**CITY OF MERIDIAN
FINDINGS OF FACT, CONCLUSIONS OF LAW
AND DECISION & ORDER**

Case No(s). H-2022-0065

SUBJECT: H-2022-0065 – West Valley Emergency
Center – MDA, CUP, ALT

C. Site Plan (dated: 9/29/2022)

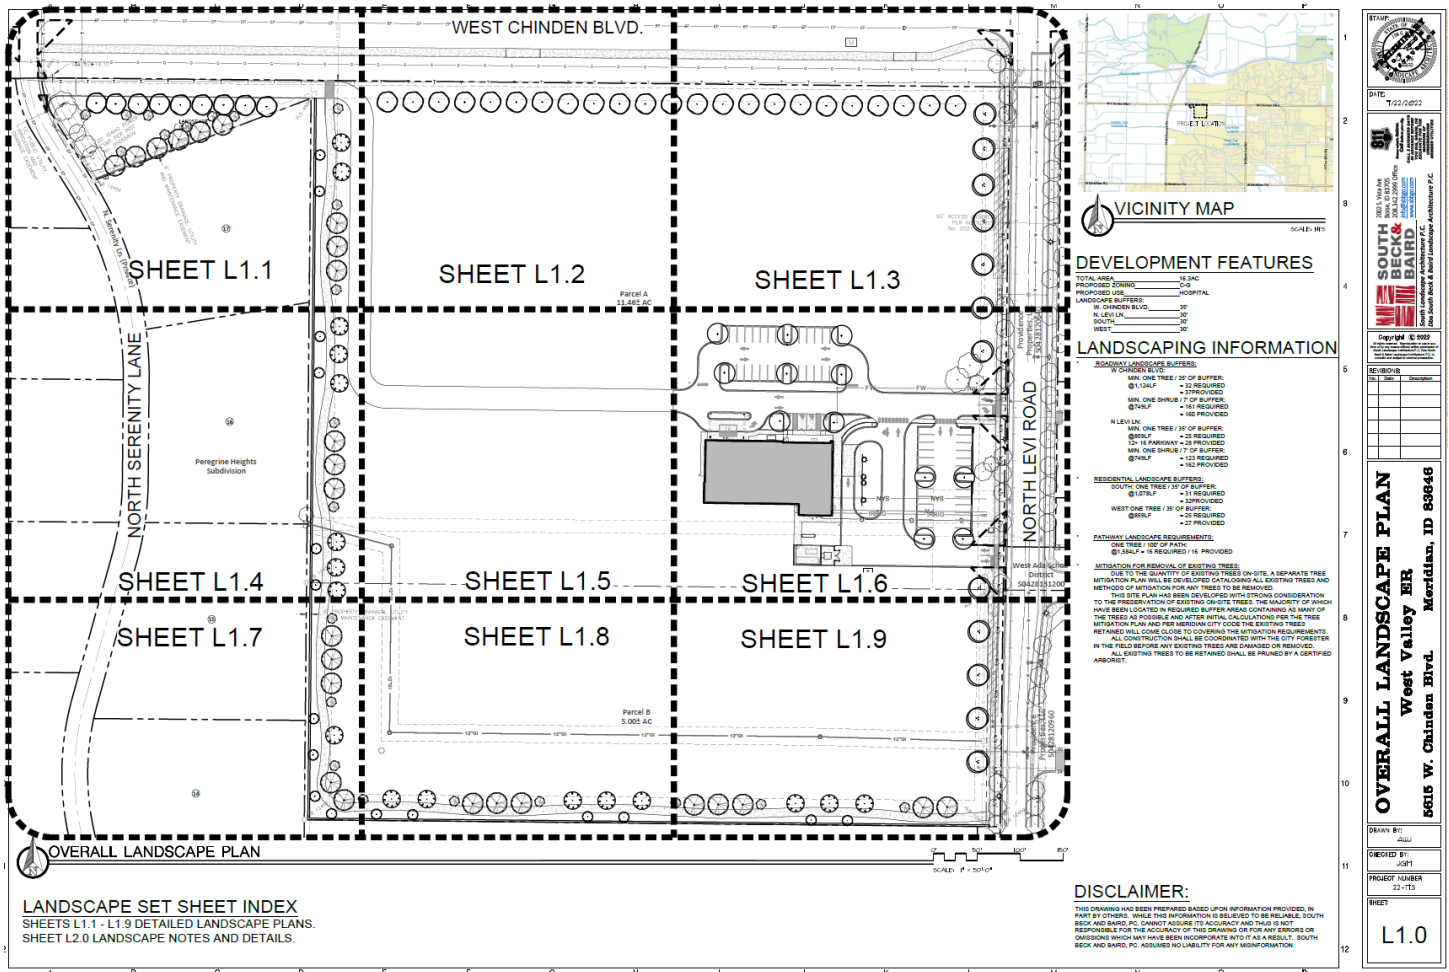
Sidewalks: A detached sidewalk is required along W. Chinden Blvd. per UDC 11-3A-17. Because the Pathways Master Plan depicts a 10-foot wide pathway along Chinden, Staff recommends a 10-foot wide detached pathway is provided within the street buffer in lieu of a sidewalk.

Pathways: Ten-foot (10') wide pathways are proposed within the street buffer along Chinden and within the land use buffers to residential uses along the west and south boundaries of the site in accord with the Pathways Master Plan. **These pathways are required to be placed in a 14-foot wide public pedestrian easement. An easement for such should be submitted to the Planning Division for Council approval and recordation prior to issuance of Certificate of Occupancy for the proposed use.**

Parking: Off-street vehicle parking is required per the standards listed in UDC 11-3C-6B.1. Based on the 11,241 square foot facility, a minimum of 22 parking spaces are required. A total of 47 spaces are proposed, in excess of UDC standards.

Bicycle parking is required per the standards listed in UDC 11-3C-6G. Based on 47 vehicle parking spaces, a minimum of two (2) bicycle spaces are required. A total of three (3) spaces are proposed, in excess of UDC standards. **Bicycle parking facilities should comply with the location and design standards listed in UDC 11-3C-5C.**

3. The site and/or landscape plan submitted with the Certificate of Zoning Compliance shall be revised as follows:
 - a. Depict the location and a detail of the bicycle rack that complies with the location and design standards listed in UDC [11-3C-5C](#).

- c. If an easement for emergency access via Serenity Lane is not attainable prior to submittal of the Certificate of Zoning Compliance application for the proposed emergency center, a barrier prohibiting access shall be erected at the west end of the frontage road. If an access easement is obtained, submit a copy of the recorded easement to the Planning Division. *Emergency access is not required with the emergency center; however, it will be required with the hospital expansion if the overall area of the building exceeds 124,000 square feet or 3+ stories in height.*

4. A 14-foot wide public pedestrian easement shall be submitted to the Planning Division for the proposed multi-use pathways within the site along the north, west and south property boundaries, prior to issuance of Certificate of Occupancy for the proposed use.

D. Landscape Plan (dated: 7/22/2022) – full plan set

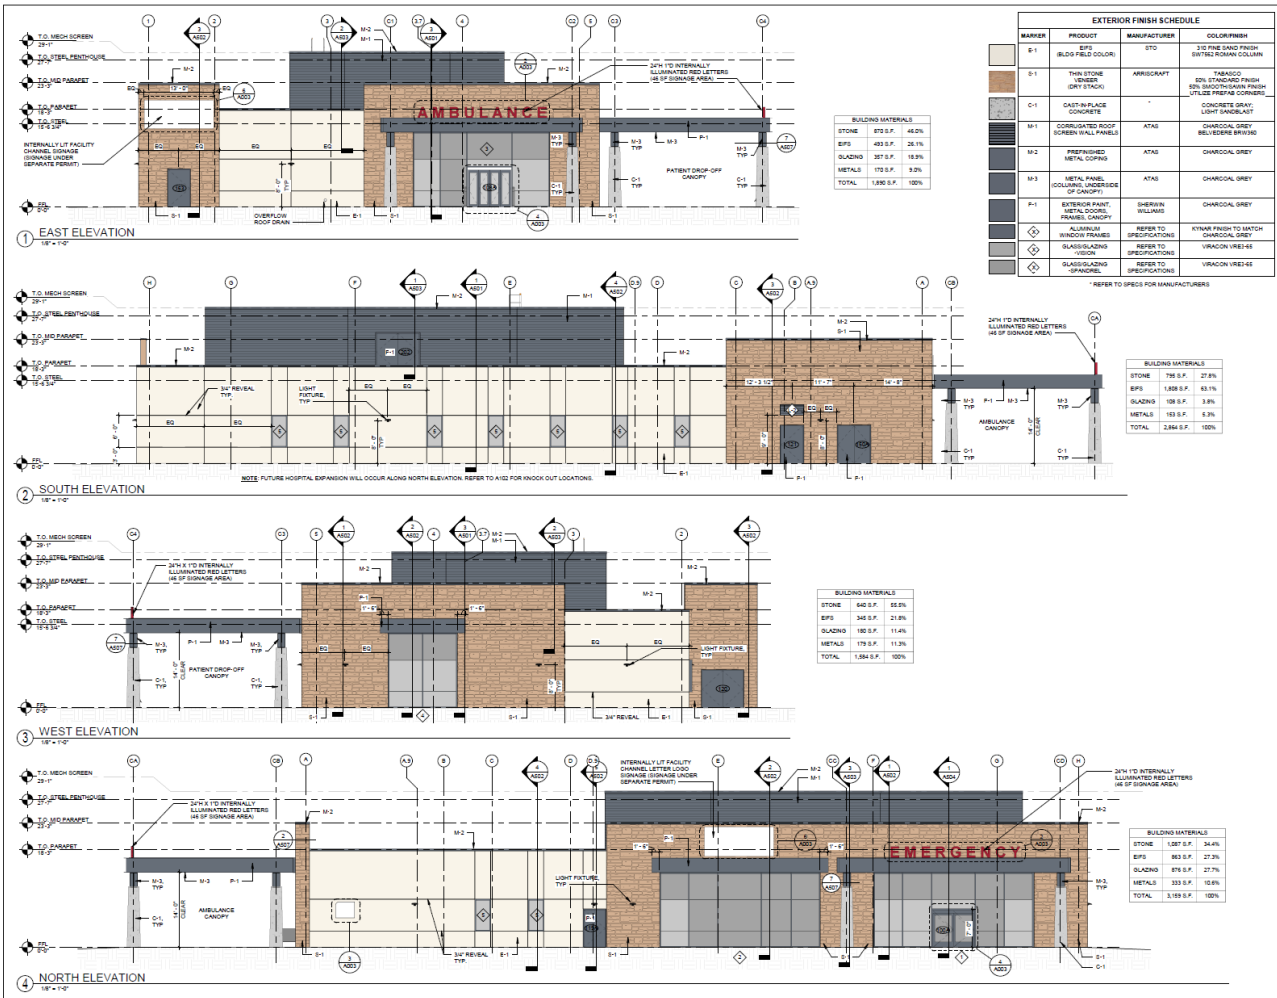
Landscaping: A 35-foot wide street buffer is required to be provided on this site along W. Chinden Blvd./SH 20-26, an entryway corridor, landscaped per the standards listed in UDC 11-3B-7C. The street buffer is measured from the back of curb; where the transportation authority is anticipating future widening of the street, the width of the buffer is measured from the ultimate curb location. There is a large expanse of land within the right-of-way along Chinden that can be counted toward the street buffer requirement if landscaped per the standards in UDC [11-3B-7C.3](#); landscaping may be allowed through a license agreement with ITD. Because this is an entryway corridor, enhanced landscaping should be installed in accord with the standards listed in UDC [11-3B-7C.3](#). **A revised landscape plan should be submitted with the Certificate of Zoning Compliance application that reflects compliance with standards listed in UDC [11-3B-7C](#), including enhanced landscaping along the entryway corridor (i.e. Chinden Blvd).**

Alternative Compliance is requested to the landscape standards in UDC 11-3B-7C.3, which require a minimum density of one (1) tree per 35 linear feet along with shrubs, lawn or other vegetative groundcover, to be installed within the street buffer along W. Chinden Blvd. On the western portion of the site, the buffer area is constrained where the emergency access road is proposed to the north of Peregrine Heights Subdivision. In this area, the trees are proposed on the south side of the driveway. Because driveways are an allowed impervious surface in street buffers and the required number of trees are proposed on the south side of the driveway, Staff sees no purpose for the request as the proposed landscaping appears to meet UDC standards; thus, Staff recommends denial of the request.

A 25-foot wide buffer is required to adjacent residential uses to the west and south, landscaped per the standards listed in UDC 11-3B-9C as proposed. A 30-foot wide buffer is proposed with an 8-foot tall wall, landscaped with a mix of evergreen and deciduous trees, shrubs and lawn, which should result in a barrier that allows trees to touch at the time of maturity.

- b. Depict a minimum 35-foot wide street buffer along W. Chinden Blvd. with landscaping in accord with the updated standards listed in UDC [11-3B-7C.3](#). Enhanced landscape design features shall be provided within the street buffer along Chinden Blvd., an entryway corridor, in accord with UDC [11-3B-7C.3f](#), including a minimum 3-foot tall berm with no less than 4:1 slope to screen the parking area. Include calculations that demonstrate compliance with the standards. *Landscaping may be allowed within the right-of-way along Chinden Blvd. with a license agreement with ITD.*
